PROJECT: 40 Princess Street B100019-AD DATE: 29/02/2024

SUBJECT: RE: File Transfer: RE: Application referenced: 138904/LO/2023 - 40 Princess Street - B100019-AD 40 Princess Street TRANSMITTAL ID: 00029

PURPOSE: For your review and comment VIA: Email

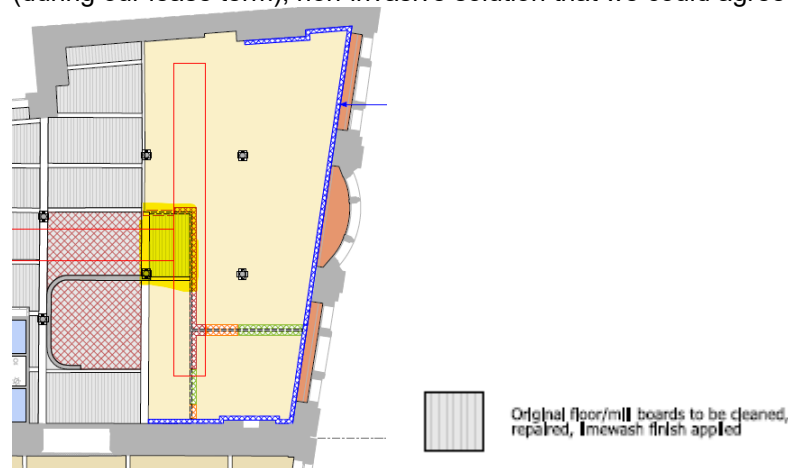
We visited site recently and noted there is a section of charred timber floor boards to the underside of the ceiling near the curved stair (see attached photo). The reflected ceiling plan states for this area to be cleaned, repaired and limewashed. We understand this is not possible and were therefore wondering if there is a temporary (during our lease term), non-invasive solution that we could agree to conceal it?
